SUBJECT: COMANCHE PEAK NUCLEAR POWER PLANT, UNITS 3 AND 4
DOCKET NUMBERS 52-034 AND 52-035
SUPPLEMENTAL INFORMATION IN RESPONSE TO THE REQUEST FOR ADDITIONAL INFORMATION REGARDING THE ENVIRONMENTAL REVIEW

Supplemental Information in Response to the Request for Additional Information Regarding the Environmental Review

QUESTION NO.: GEN-03 (3.6.1-1) HYD-23 (9.4.2.2.5-1) and LU-03 (5.5.1.1.2-1)

Figure 3.6-1 Sketch of Blowdown Water Treatment Facility Per Unit

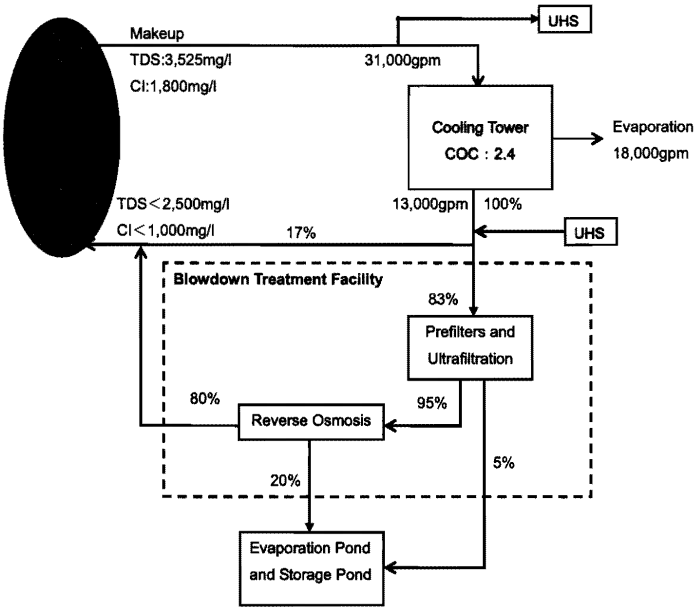
For the discussions below, refer to Figure 3.6-1. The normal flow path of BDTF at the design conditions will take approximately 83 percent of the blowdown flow and divert it to the facility for treatment. Approximately 95 percent of the diverted water is filtered water and will be sent to the R/O unit. Approximately 80 percent of the filtered water will become treated water and will be reverted back to the main blowdown stream. Approximately 5 percent of the diverted water is reject water from the filters and approximately 20 percent of the filtered water is reject water from the R/O units. The reject water above will become waste water, which will be backwash containing the rejects from pre-filters, ultrafilters, and R/O membranes and will be routed either directly to the misters or the storage pond. If there are insufficient misters available (due to maintenance) to evaporate the total amount of design flow, the excess will be diverted to the storage pond and then be sent to the misters when load demand improves. New Subsection 3.6.1.4 that discusses the BDTF flow process has been added to the ER.

See attached marked-up ER Revision 1 pages 2.3-43, 2.3-164, 3.4-4, 3.6-2, 3.6-4, 3.6-5, 3.6-6, 3.6-7, 3.6-8, 3.6-9, 3.6-10, 3.6-11, Figure 3.6-1, 4.2-3, 5.2-4, 5.2-12, 5.2-15, 5.5-4, 9.2-57, 9.2-58, 9.4-17, and 9.4-22.

Figure 3
Simulated Lake Granbury Elevations
Scenarios A and C – 2020 Conditions

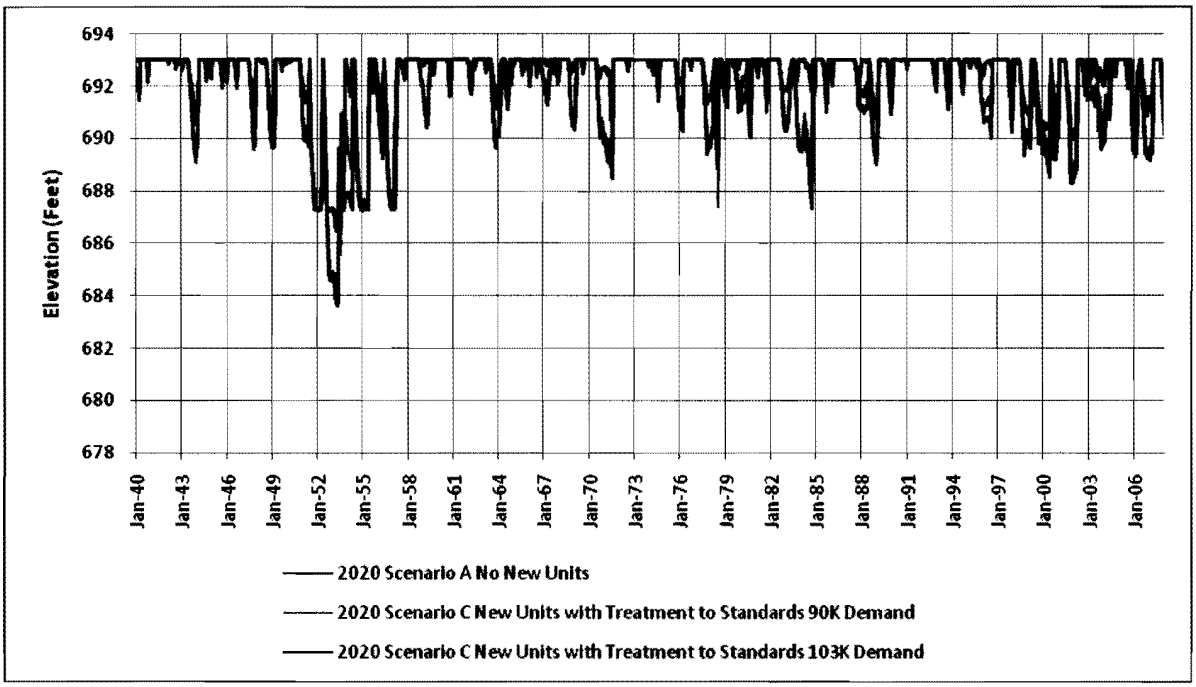
5. Figure 3 compares the simulated elevations in Lake Granbury for Scenarios A and C under 2020 conditions. Scenario A is shown in blue. Scenario C includes demands at both 90,152 (shown in green) and 103,717 acre-feet per year (shown in red). Figure 4 shows the exceedence frequency of the elevations in the same reservoir. Attachment 2 contains tables with the data used to create these graphs. Without the demands for the new units (Scenario A), the reservoir is full about 57 percent of the time. With the new units (Scenario C), Lake Granbury is full about 48 percent of the time at the 90,152 acre-feet per year demand level and about 46 percent of the

Figure 5
Simulated Lake Possum Kingdom Elevations
Scenarios A and C – 2020 Conditions

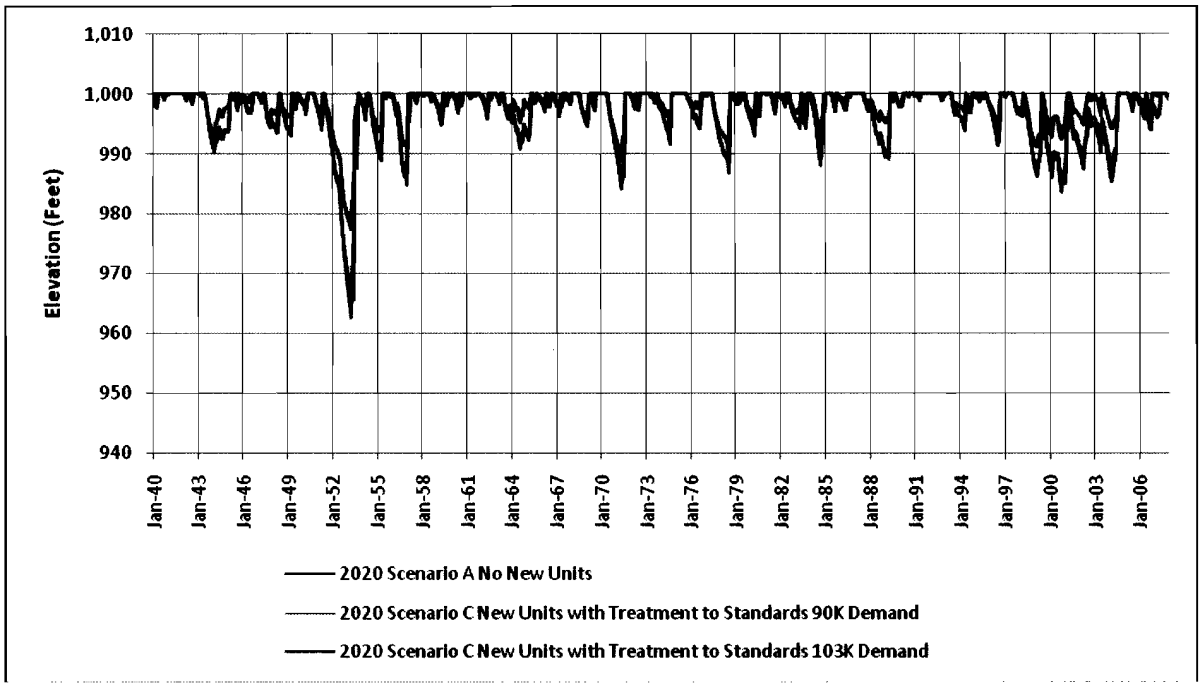
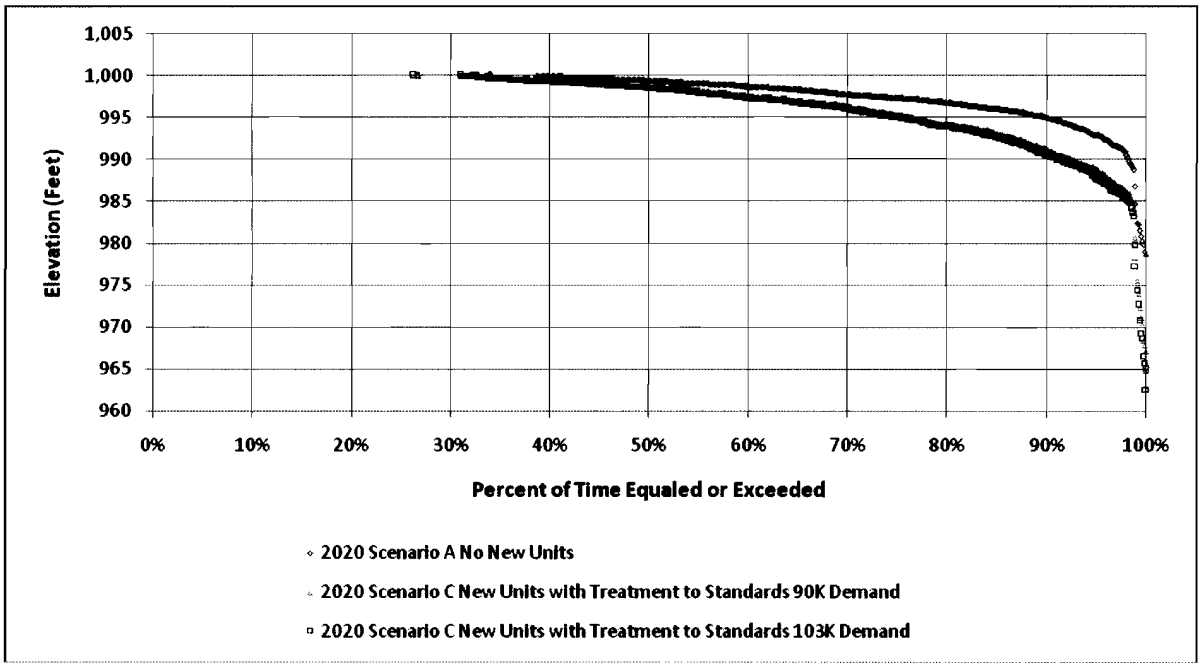
6. Figures 5 and 6 show the simulated elevations and exceedence frequency for Lake Possum Kingdom, respectively. Attachment 2 contains tables with the data used to create these graphs. Without the new units (Scenario A), Possum Kingdom is expected to be full about 34 percent of the time. With the new units, the reservoir is full about 27 percent of the time at the 90,152 demand level and 26 percent of the time at the 103,717 acre-feet per year demand level. At the reservoir's lowest point in April 1953, with units 3 and 4 the reservoir is 12.6 feet lower at the 90,152 acre-feet per year demand level and 14.8 feet lower at the 103,717 acre-feet per year demand level. On average, in Scenario C the reservoir is 1.3 feet lower at the 90,152 acre-feet per year demand level and 1.5 feet lower at the 103,717 acre-feet per year demand level.

Figure 7
Simulated Annual Outflow from Lake Possum Kingdom
Scenarios A and C – 2020 Conditions

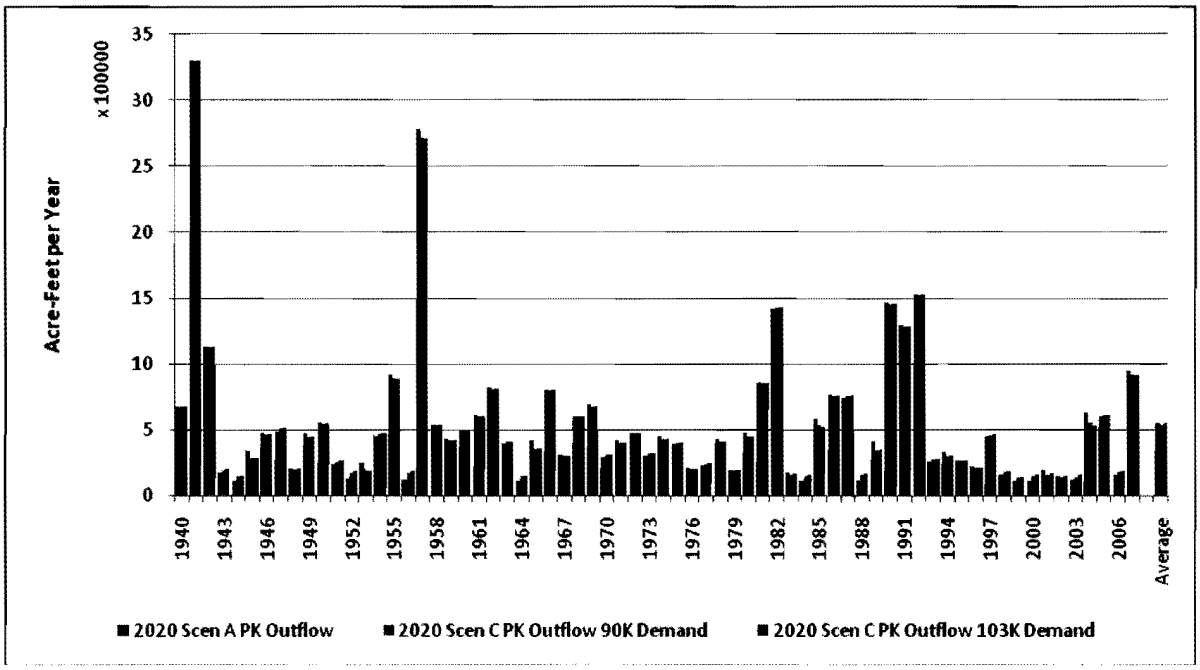
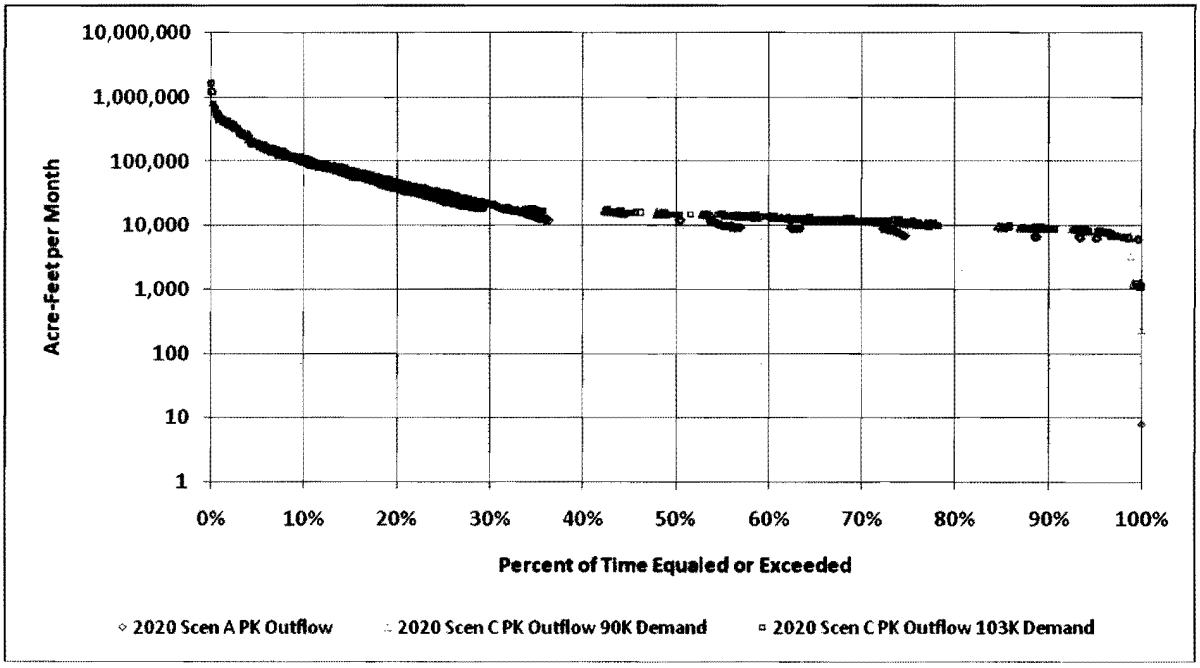
7. Figure 7 shows the modeled annual outflow from Lake Possum Kingdom. Figure 8 shows the exceedence frequency of the monthly outflows from the same reservoir. These values are plotted on a logarithmic scale because of the wide range of values. Figure 9 shows the monthly median outflow from the reservoir. Figures 10, 11 and 12 show the same data for the inflows to Lake Granbury. Attachment 2 contains tables with the data used to create these graphs. These graphs do not show as much difference in flows in this reach as would be expected from the changes in elevation shown in Figures 5 and 6. There are two explanations for this. First, releases from Possum Kingdom when the reservoir is relatively full are similar in both scenarios. Second, the larger spills from Lake Possum Kingdom in Scenario A sometimes mask the increased outflow during dry periods in Scenario C. For example, during the period from July 1951 to April 1953 about 246,000 acre-feet was passed downstream in Scenario A. In Scenario C at the 90,152 acre-feet per year demand level, 338,000 acre-feet was passed downstream during the same period, an increase of 92,000 acre-feet. However, when the reservoir refills in October 1953, in Scenario A 145,000 acre-feet of water spills from Possum Kingdom. In the same month in Scenario C at the 90,152 acre-feet per year demand level, only 37,000 acre-feet spills from the reservoir, a change of 108,000 acre-feet. Even though the outflows are

Figure 13
Simulated Annual Outflow from Lake Granbury
Scenarios A and C – 2020 Conditions

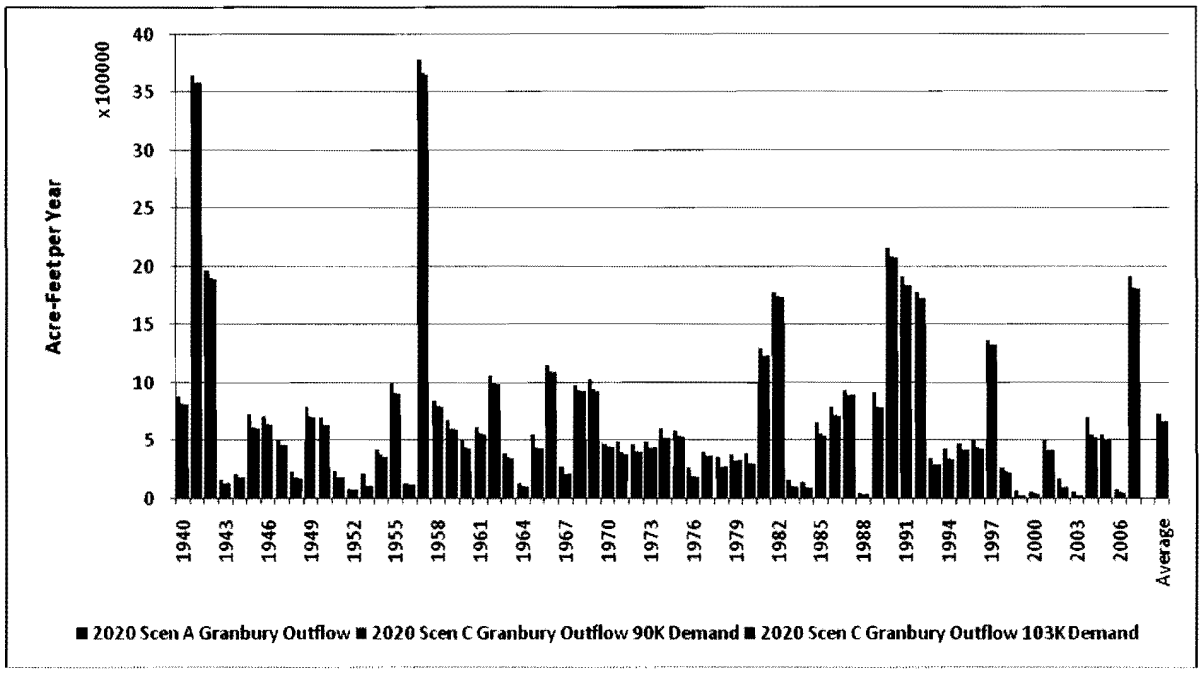
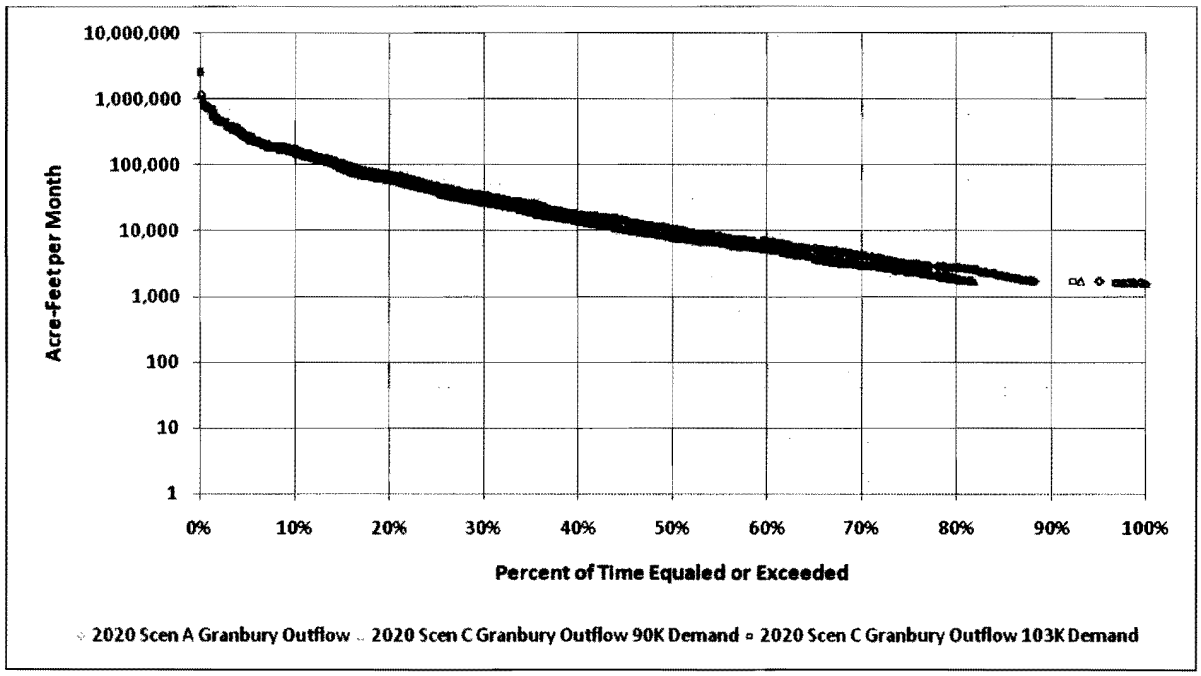
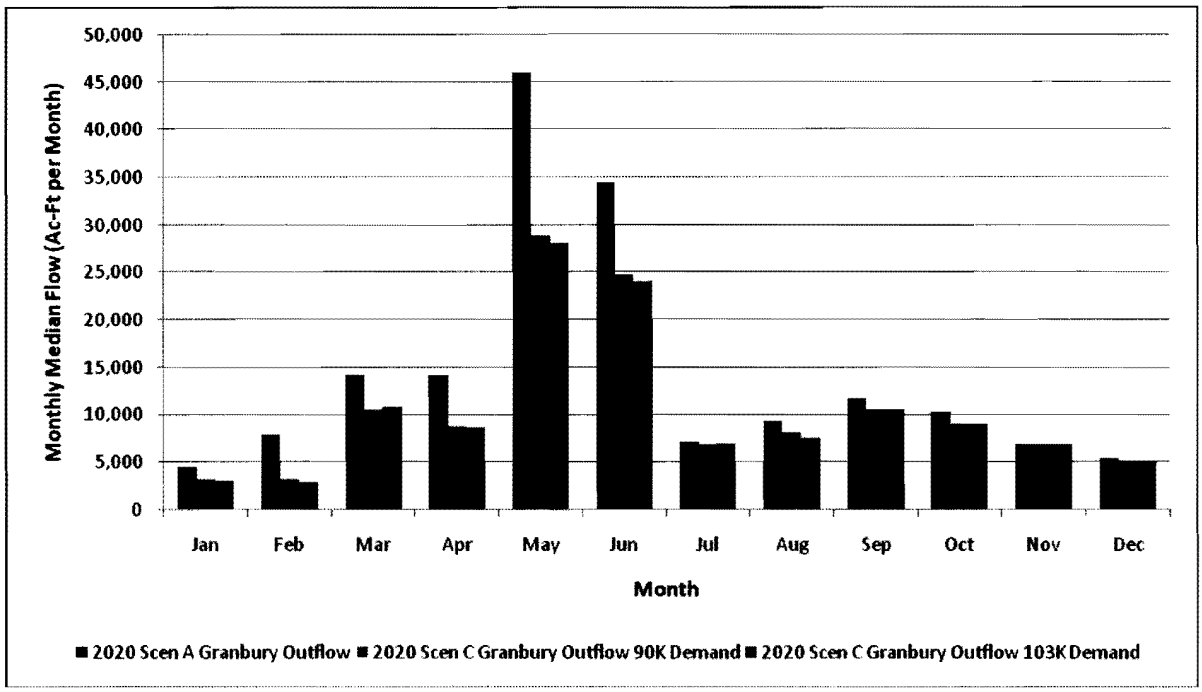
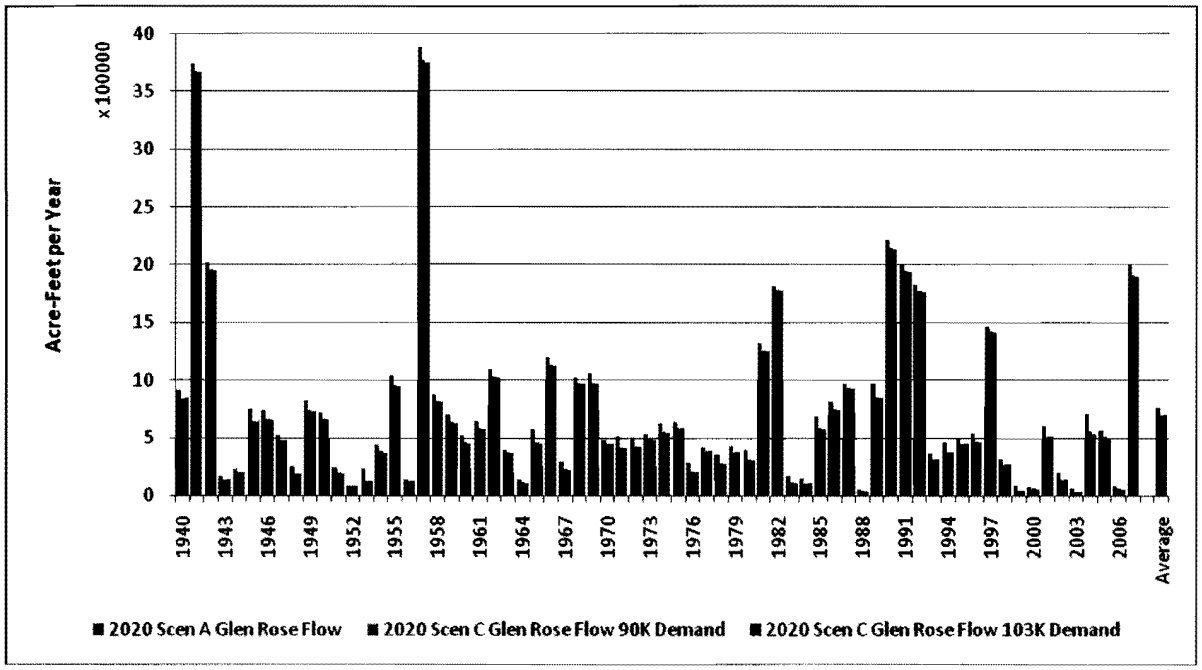
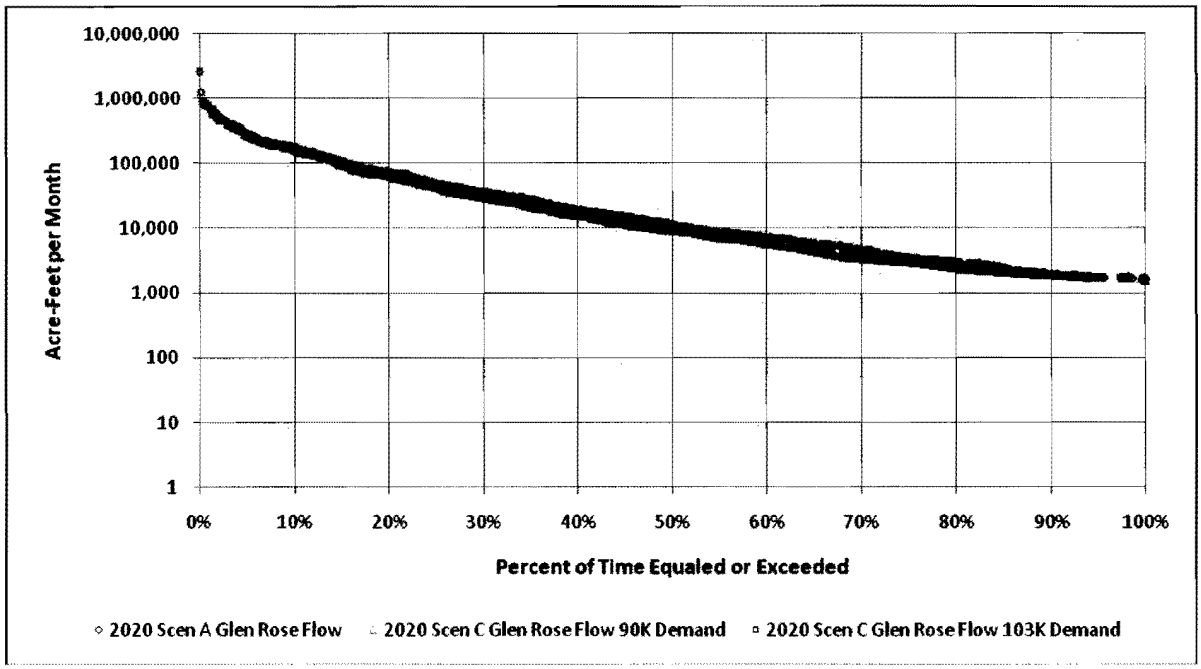
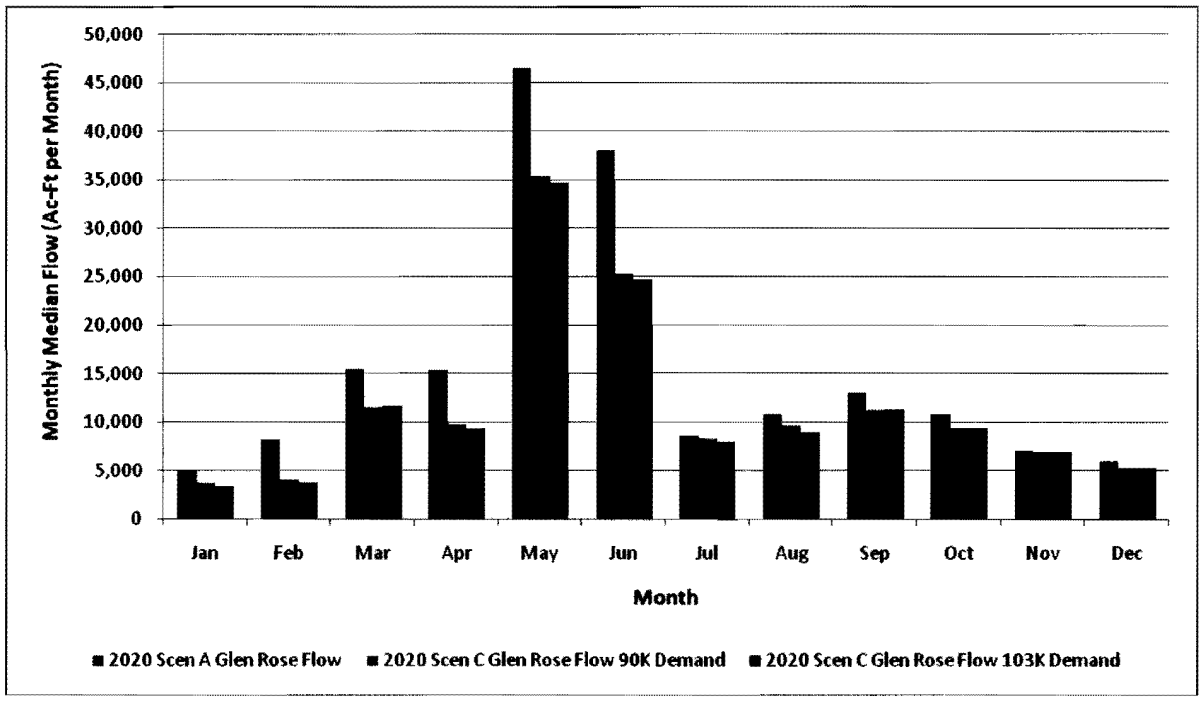
8. Figure 13 shows the annual outflow from Lake Granbury. Figure 14 shows the exceedence frequency of the monthly outflows and Figure 15 shows the monthly medians of the outflows. Figures 16, 17 and 18 show the same data at the Glen Rose gage. Attachment 2 contains tables with the data used to create these graphs. The outflows from Lake Granbury are similar for larger and smaller outflows. As the volume of the outflows decreases, the difference between Scenarios A and C becomes more pronounced, with generally lower outflows in Scenario C (with Units 3 and 4). At the lowest end of the flow range flows are governed by the constant minimum release of 28 cfs. The outflows from the reservoir are similar at both the 90,152 and 103,177 acre-feet per year demands.
